## Maintenance manual DG-800 B MW

## **Manual amendments**

Issued: December 2023 TN 800/50 2

## 1.2.3 Elevator stops

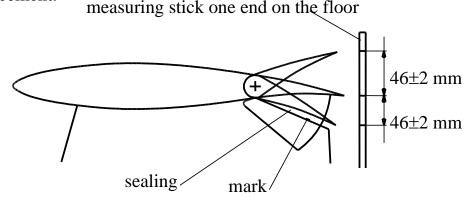
## Free play within the automatic elevator connection

Within the automatic elevator connection there should be no free play noticeable in the zero position when the elevator is moved at its trailing edge.

Any free play can be reduced by screwing in the adjustment screw on the automatic connector funnel.

**Warning:** In case the adjustment screw was turned in too far, the roller will jam inside the funnel and can't be moved or only with larger force to the front of the funnel. Moving the horizontal tailplane backwards for rigging might not be possible or only with large effort. Each time a bending force will act on the rod end which might lead to failure of the rod end with time.

For this reason after adjusting the free play it is necessary to check if the roller can be moved without force in the funnel.

To accomplish this, remove the compete rod end with the roller or remove the roller from the rod end and stick it on an 8 mm f7 pin and move the roller in the funnel. Prior to removal of the rod end mark it's position.

If the roller can't be moved without force completely zo the front you must turn back the adjustment screw and bend back the sheet metal which was bent by the adjustment screw. Then adjust the free play again.

In case the roller has too much free play on the rod end or if the roller is no more round you must replace the roller by a new one 8St50/2.

In case the glider was operated for a longer time with the adjustment screw turned in too far the rod end must be replaced by a new one 8St50/1.

After completion of this work check the elevator displacements and adjust if necessary.
